Green Mountain Preliminary Overall Area Development Plan

CITY OF SAN ANTONIO POADP APPLICATION

POADP # 650

P.O.A.D.P REVIEW

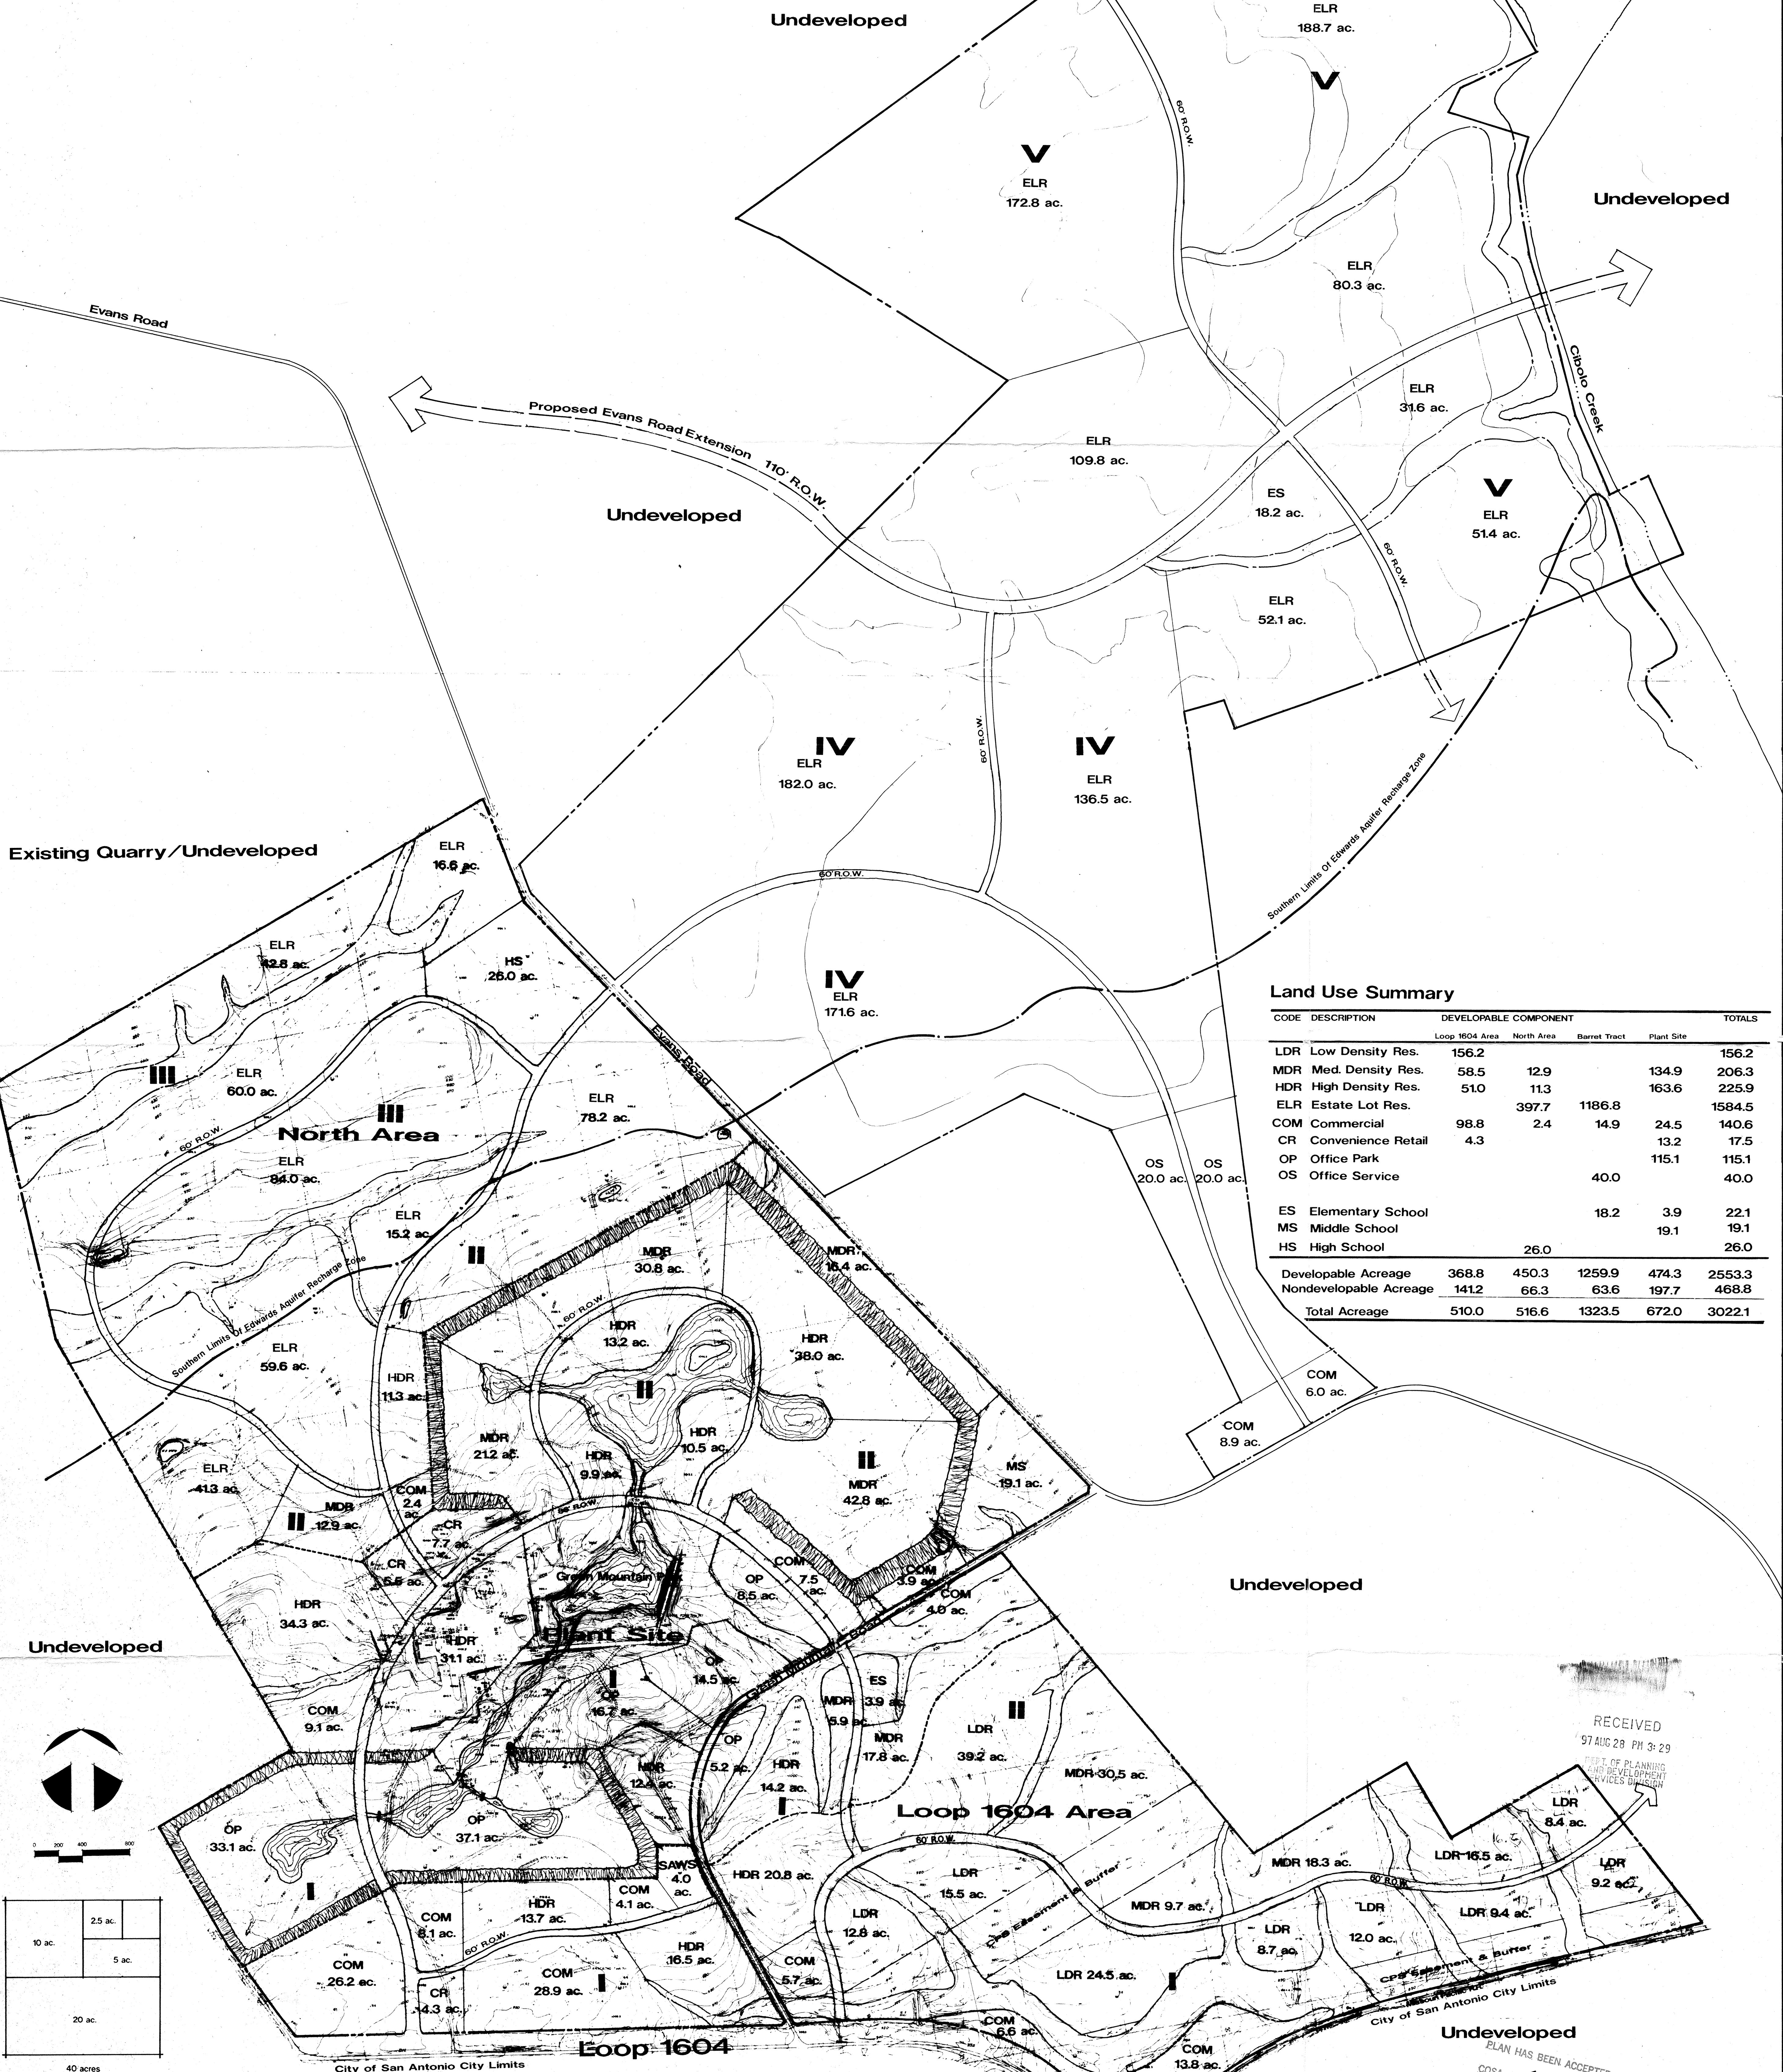
- Based on the topography, a Flood Plain Study and drainage review will probably be required during the platting process.
- In consideration of public safety and convenience, excessive grades by reason of topography should be avoided in street layouts and arrangements.

- This development will probably need to conform to requirements associated with development over the Edwards Aquifer. For additional information about these requirements you can contact SAWS at 704-7305.

- Access and R.O.W. issues along State facilities will need to be resolved with the Texas Department of Transportation (TXDOT). For information about these requirements you can contact TXDOT at 615-5814.

- This development will need to comply with tree preservation ordinance #85262. For information about these requirements you can contact Building Inspections at 207-7102.

- It will be expected that you will plat all of the property depicted in your POADP, to include: floodpains, drainage areas and open space.
- I would encourage you to work closely with the school district, so that they can plan accordingly.

For residential development directly adjacent to State ROW, the developer shall be responsible for adequate set-back and/or sound abatement.

All access locations, number of access points and permitting will be as directed by "Regulations For Access Driveways to State Highways".

Permit applications along with plans for street, driveway, utility, sidewalk and drainage construction must be submitted to the Texas Department of Transportation for review and approval before working on highway ROW. TxDOT requires that a recorded plat accompany all driveway permit applications. The Owner/Developer is responsible for preventing any adverse impact to the existing drainage system within highway ROW.

1. TIA Regd.
2. Row of Green Mountain is 86'
3. Snow collector street system

Comments: 1. Show Row of Major thoroughfare
2. Check the possibility of providing better
alignment of Green Mountain

Flood plain requirement and drainage
requirements will be require and will be address during
the platting process.

Drainage Easements and Flood Plain
Study will be required and address
during the Platting process. Maintain
Flow patterns on to and off their property
